# Service Bulletin

Bulletin No.: 23-NA-030

**Subject: Airbag Light On - DTCs B0014 / B0021 SIAB Harness Connector Contacting Seat Back Foam (New Seat Back Foam), Intermittent Service Airbag System Message, DTCs B0014, B0021**

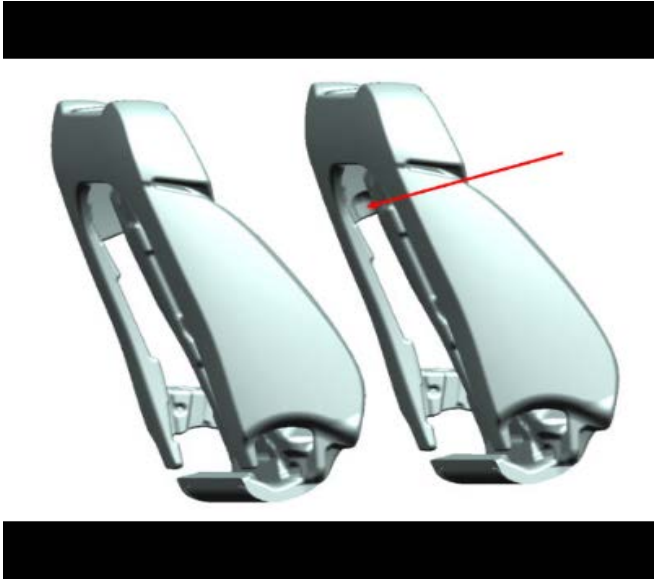
<b>Involved Region or Country</b>	North America, Middle East, Brazil, GM Korea Company
<b>Condition</b>	Some customers may comment on a "Service Restraint System" message displayed in the driver information center (DIC). Some customers may also comment on the Airbag Readiness Light coming on intermittently after start up. Technicians may also find DTC B0014 or B0021 with symptom byte :04 or :0D active or in history.
<b>Cause</b>	The condition may be caused by an interference between the front seat back pad assembly and the side impact airbag wiring harness assembly.
<b>Correction</b>	<div style="text-align: center;">  </div> <p style="text-align: right;">6325181</p> <p>Replace the front seat back pad assembly with a new part number that includes a larger clearance zone for the side impact airbag wiring harness assembly.</p>

If you encounter a vehicle with the above concern, replace the front seat back pad. Refer to *Front Seat Back Cover and Pad Replacement* in SI.
